Riverside Park Boardwalk Replacement

ITB No. 4544

ADDENDUM No. 1

EXISTING CONCRETE APPROACH DETAIL

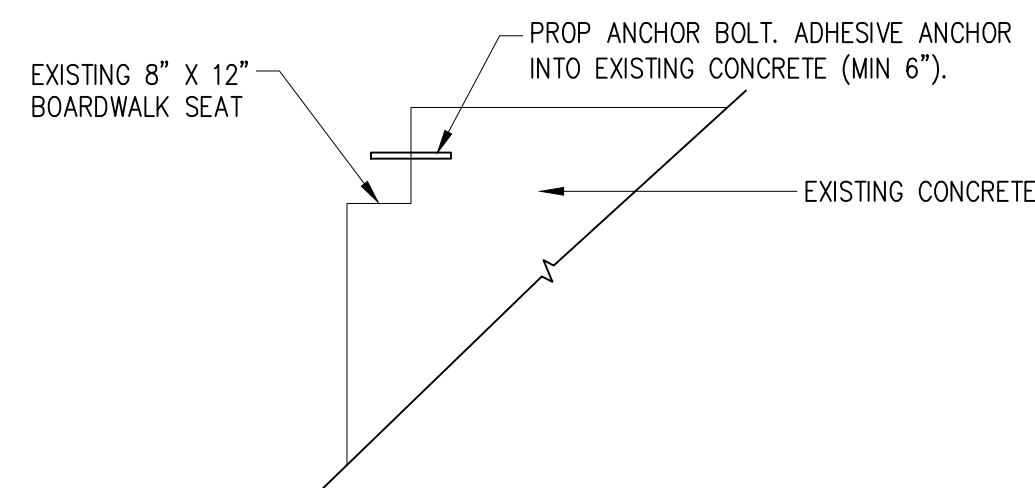
Question 7: I can't locate a detail on the plans or specifications that describe what should be included in the pay items: Structural Steel, Mixed, Erect 1,017 lb, Structural Steel, Mixed, Furn and Fab 1,017 lb, and Adhesive Anchoring of Horizontal Bar, 5 ea. Please describe the Measurement and Payment on what is included for each of the pay items.

Answer 7: Refer to the MDOT 2012 Standard Specifications for Measurement and Payment. The structural steel pay item is for the boardwalk support bracket (Sheet 5, Boardwalk Support Detail and Bracket). The Adhesive Anchoring pay item is intended for the anchoring of the anchor bolts to the existing concrete approach at the POE (Sheet 4, Existing Concrete Approach Detail).

BOARDWALK RAILING ELEVATION

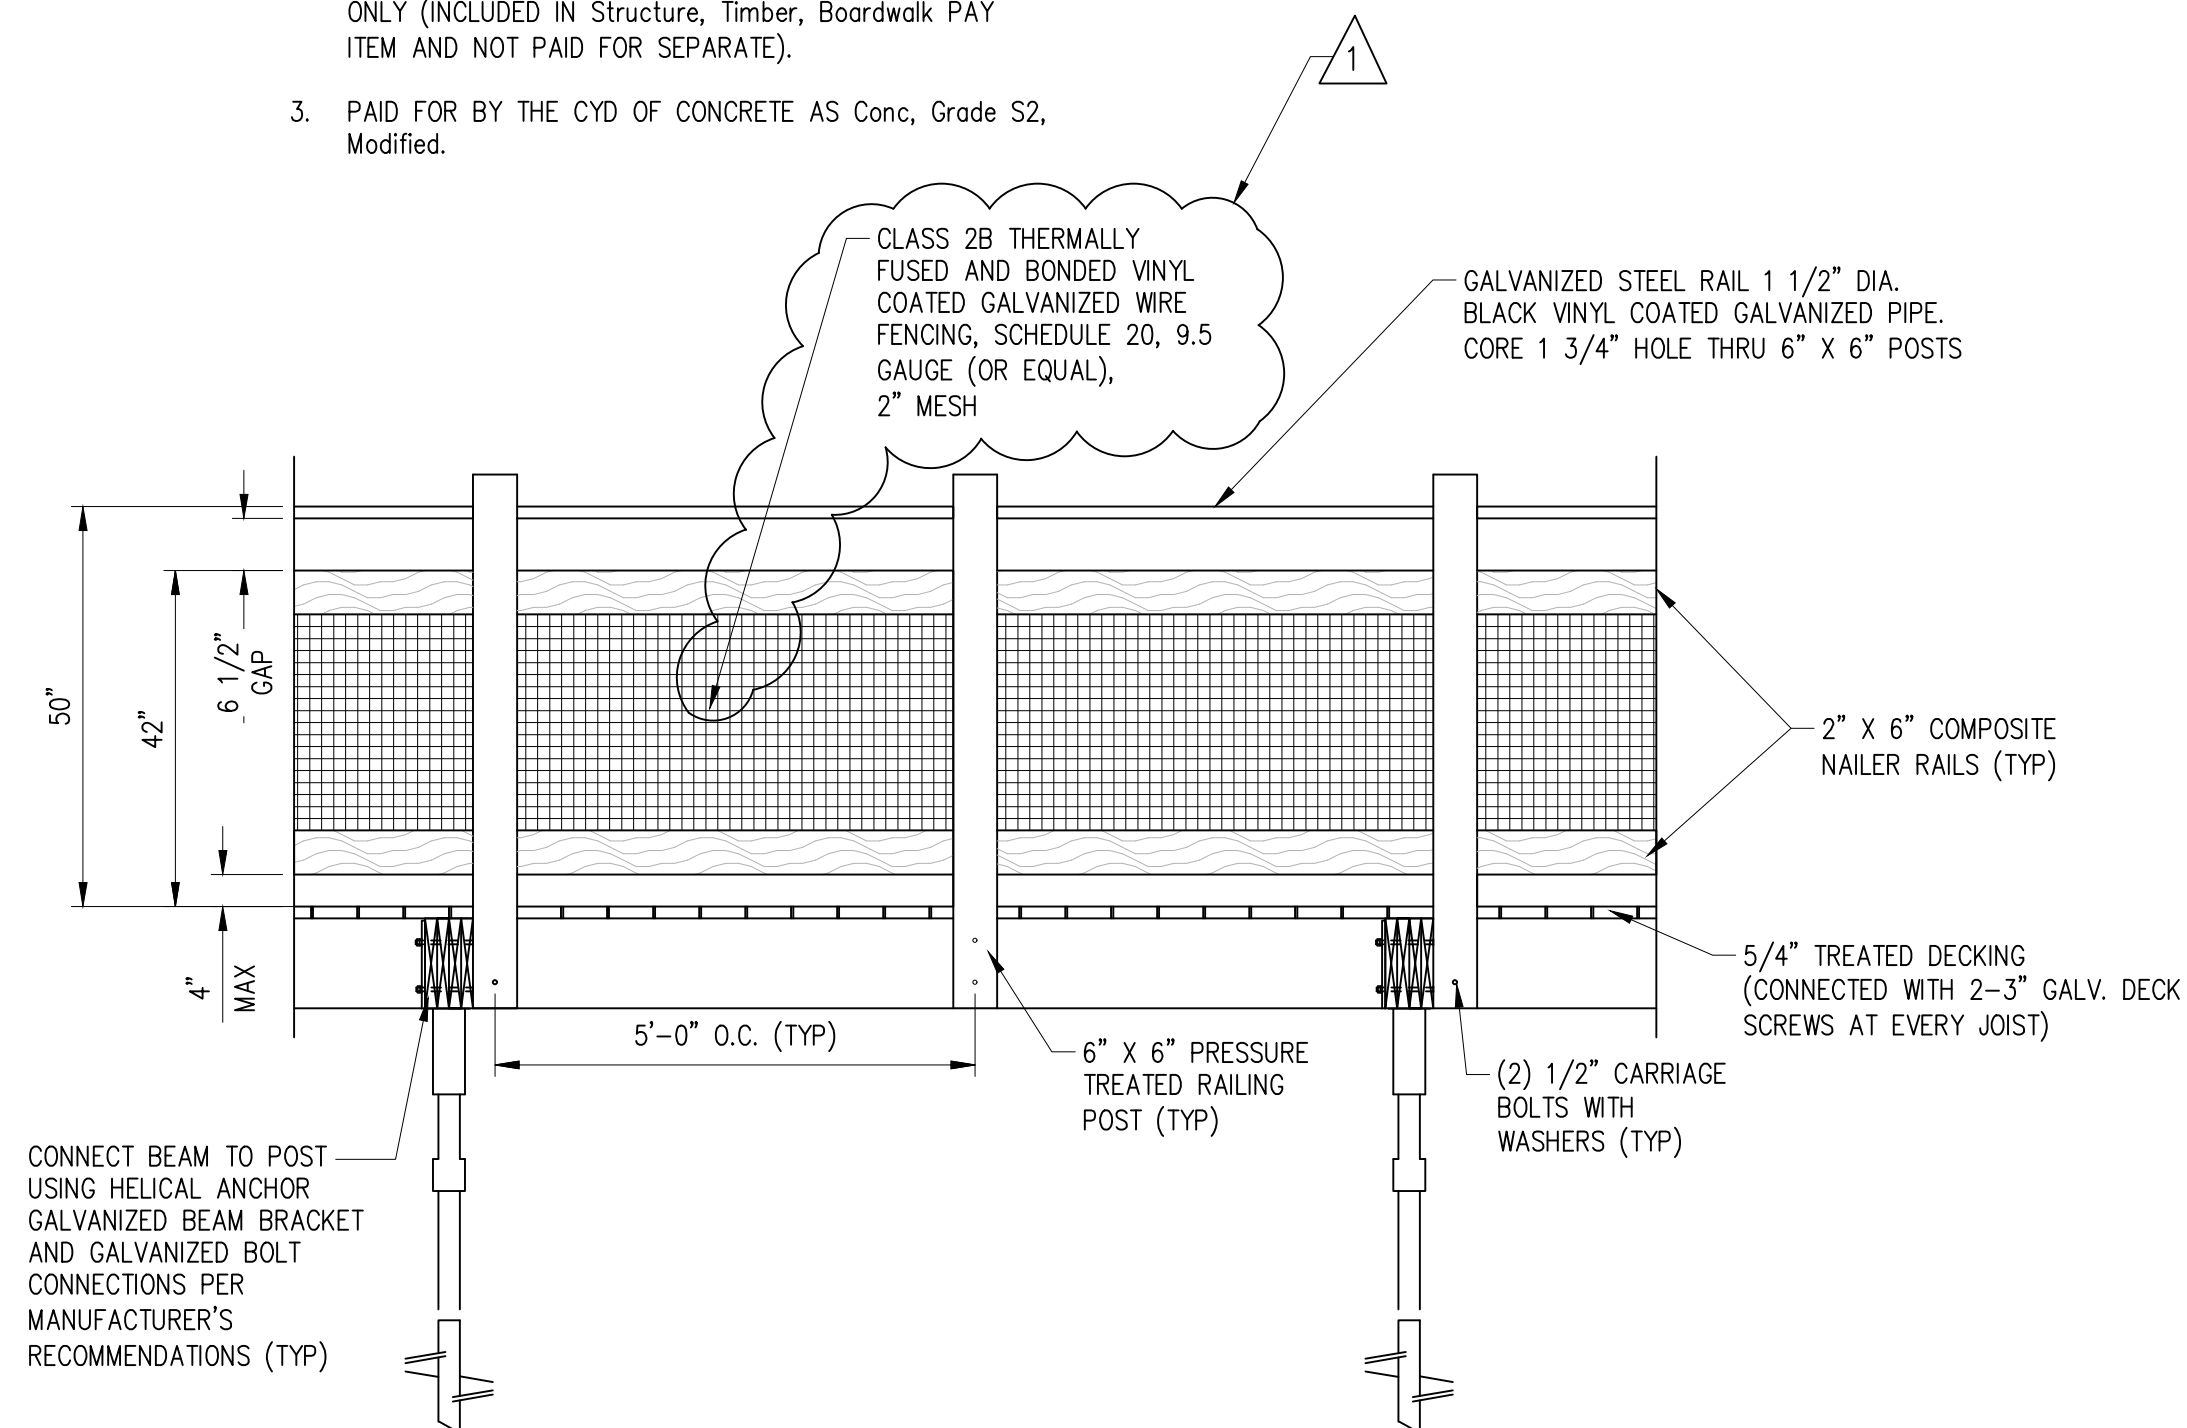
Section/Page(s)	Change
Drawing 4	Updated the wire mesh specifications on the Boardwalk Railing Elevation.
Drawing 7	Updated to reflect revised site access.
